AUGUSTA SUBDIVISION, UNIT FOUR

APPLICATION NUMBER 16 DATE October 16, 2003
APPLICANT Augusta Subdivision, Unit Four
REQUEST Subdivision

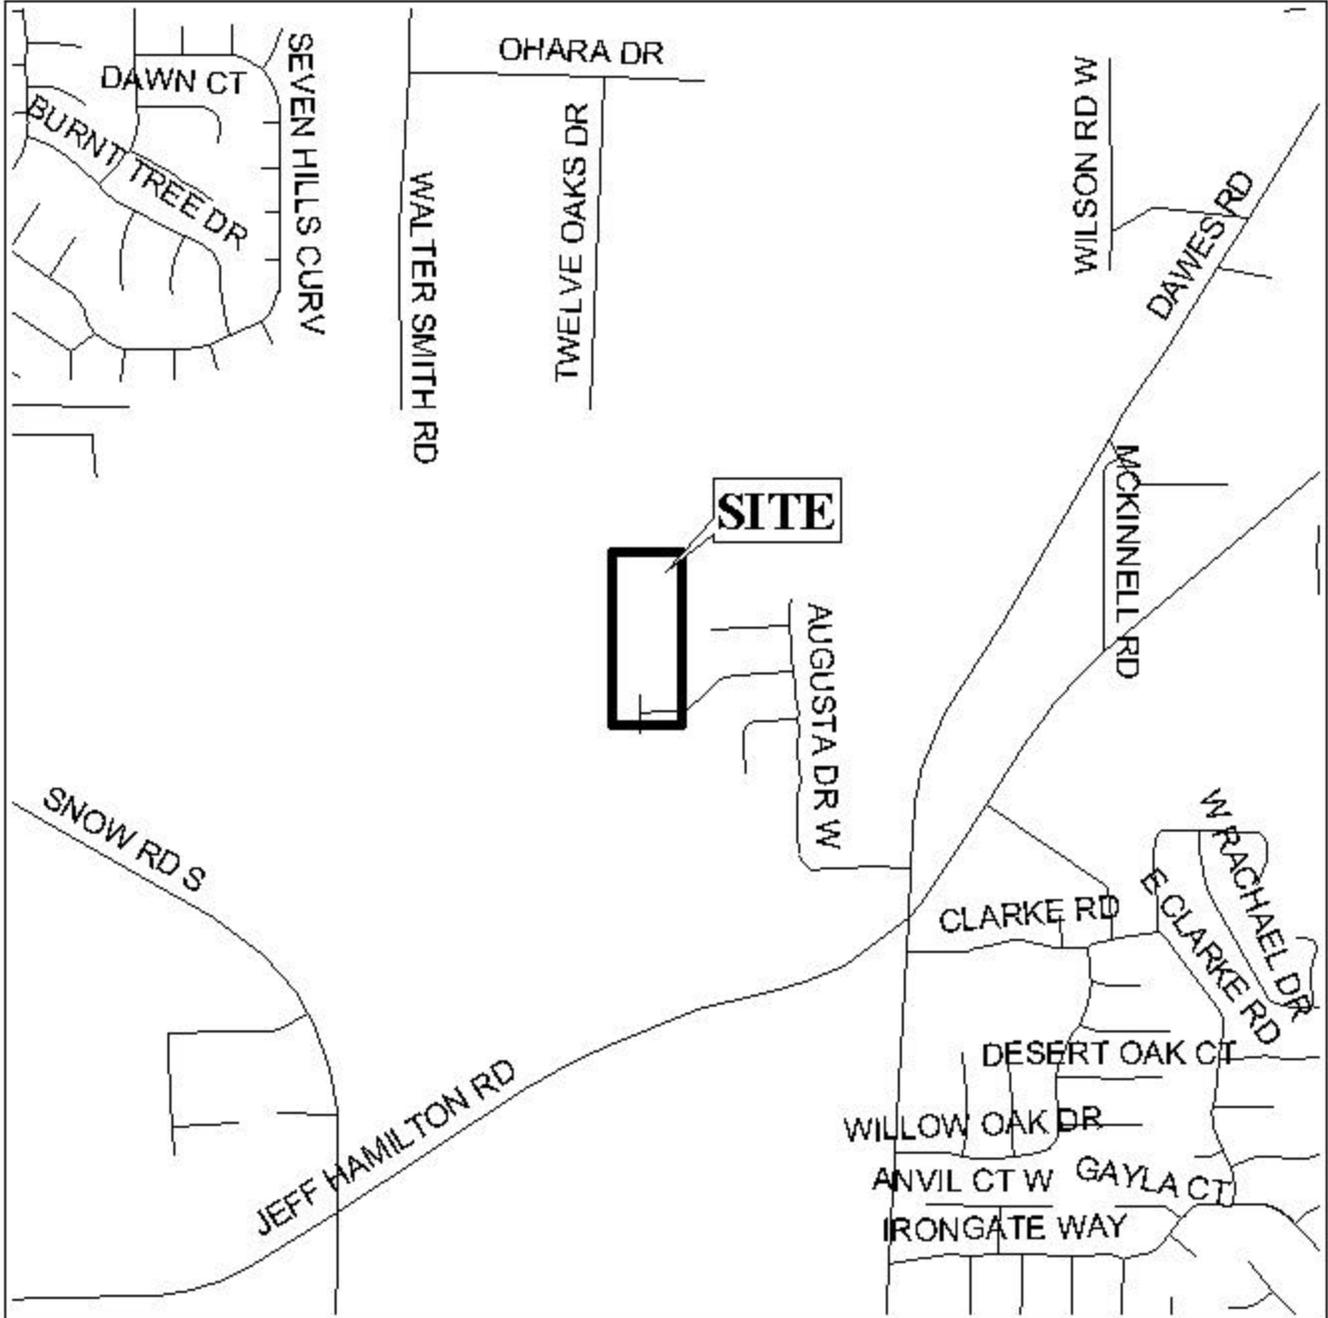
Engineering Comments: Must comply with the Mobile County Flood Damage Prevention Ordinance.

The Subdivision Regulations require a 25' minimum front yard setback; however, the applicant is proposing a 20-foot front yard setback for Lots 9-15 due to topographic reasons.

This site is located in the County, thus a note should be placed on the final plat stating that any lots which are developed commercially, and adjoin residentially developed property, must provide a buffer, in compliance with Section V.A.7. of the Subdivision Regulations.

With a waiver of Section V.D.9., the plat meets the minimum requirements of the Subdivision Regulations and is recommended for Tentative Approval subject to the following conditions: 1) no additional units of Augusta being recorded until the second connection to Woodberry Forest (formerly known as Addition to Augusta) is constructed and dedicated to County Engineering standards; 2) the provision of a 20-foot front yard setback for Lots 9-15; 3) the placement of a note on the final plat stating that any property developed commercially and adjoining residentially developed property will provide a buffer in compliance with Section V.A.7. of the Subdivision Regulations.
